RE: S4.55(1A) MODIFICATION APPLICATION TO SSD 14_6848 IN RELATION TO THE STAGE 3B DEVELOPMENT AT LISMORE BASE HOSPITAL

The subject application specifically relates to the approved Stage 3B2 North Tower.

Figure 2 Proposed Amended Level 3 Plan (Source: CGA)

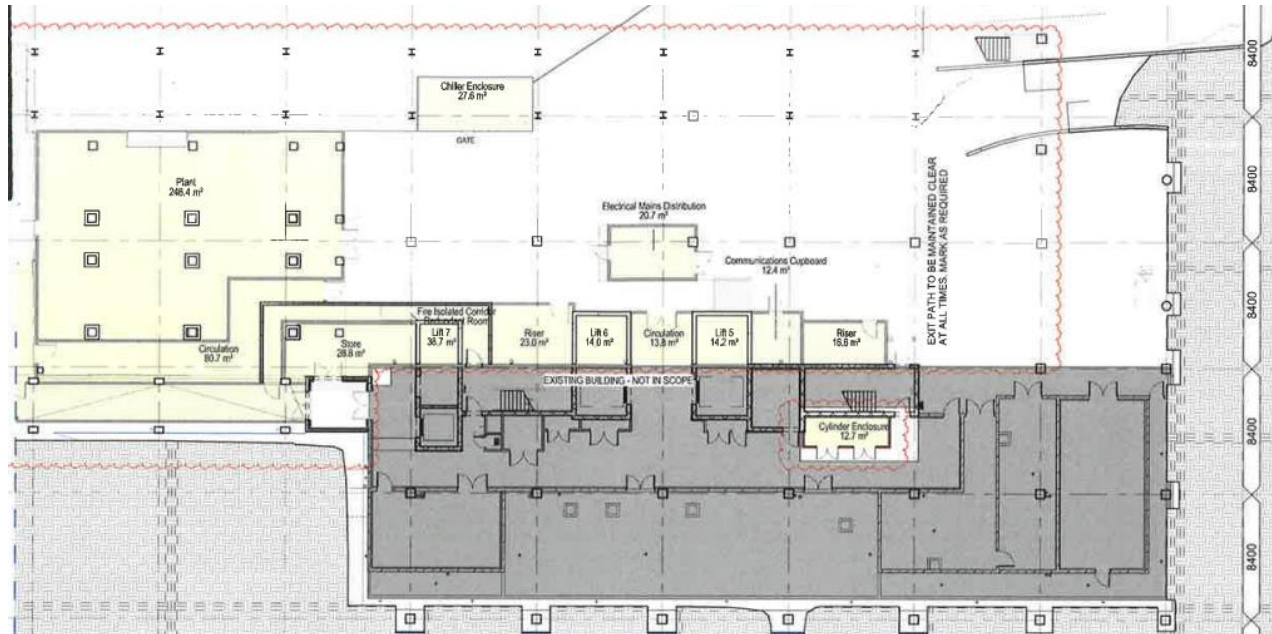
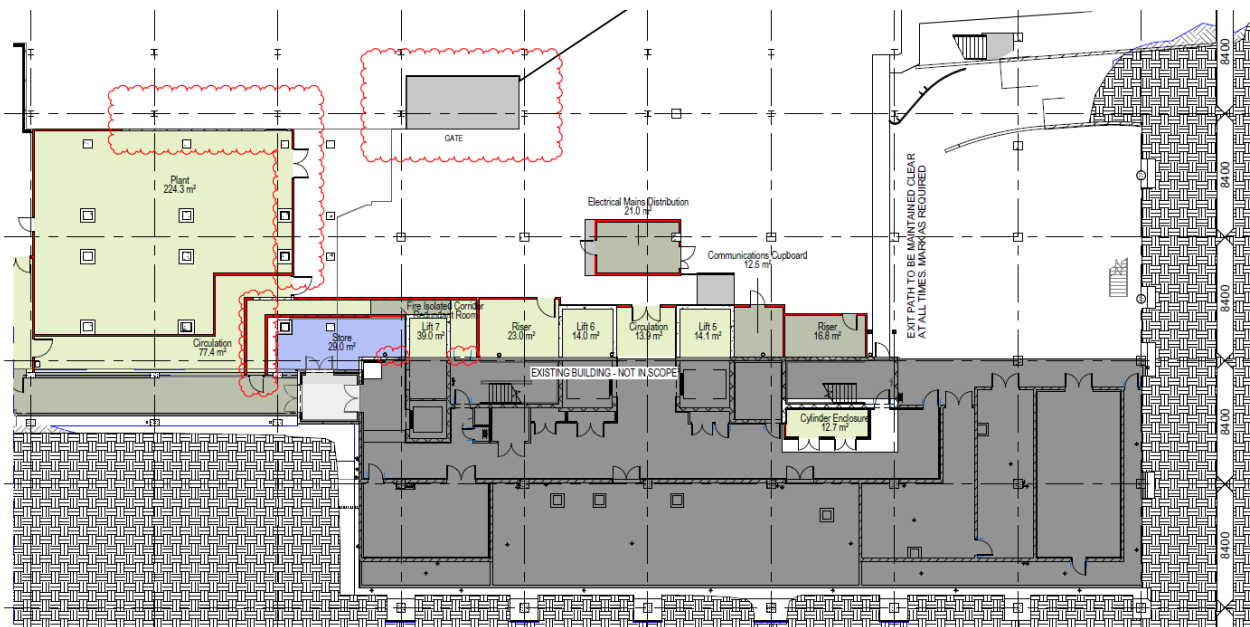
- Level 3: Reduction in the extent of plant, removal of the chiller enclosure (noting this area will become an extension to the general level 3 undercroft hardstand area), realignment of a fire passage, minor modification to the extent louvres in nominated locations, the fire passage door has been removed at 'stair 1' (to satisfy fire engineering requirements) and relocation of the door to the main plant space further north to better align with final plant layouts. Refer to the following comparative Level 3 floor plans for a visual representation of the proposed changes.

Figure 3 Approved Northern Elevation Plan (Source: CGA)

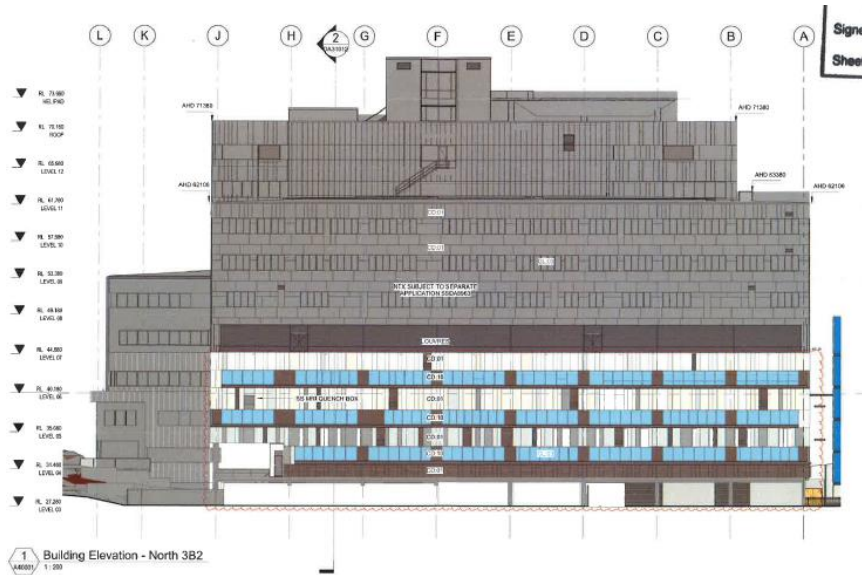
- Northern Façade: adjustment of the approved quench pipe location and design at Level 5, inclusion of a security gate at Level 4, minor adjustments to the wall alignment and extent of louvres within "grid C" at Level 3 (refer to attached plans for grid locations) and inclusion of mechanical relief air duct at "grid B" at Level 3;

Figure 6 Amended East and West Elevation Plan (Source: CGA)

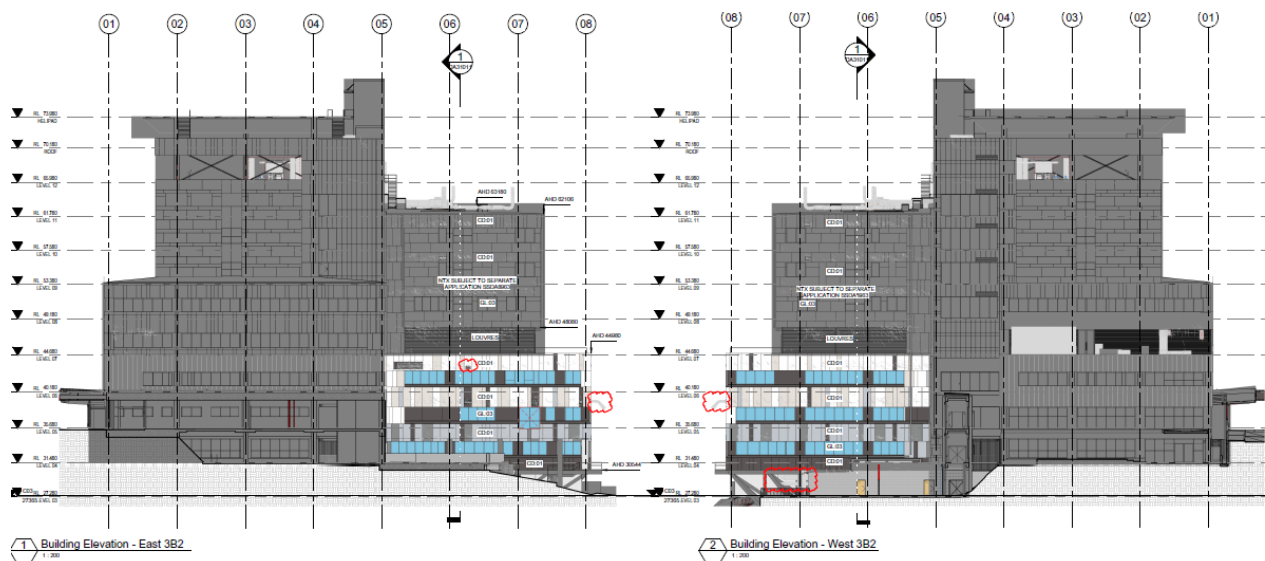
- Eastern and Western Façades: mechanical louvre added at Level 6 (within grid 6) and as above, the quench pipe box location and design has been amended at Level 5 (within grid 8), noting it is also visible from both the eastern and western elevations. Refer to the following comparative elevations for further detail.
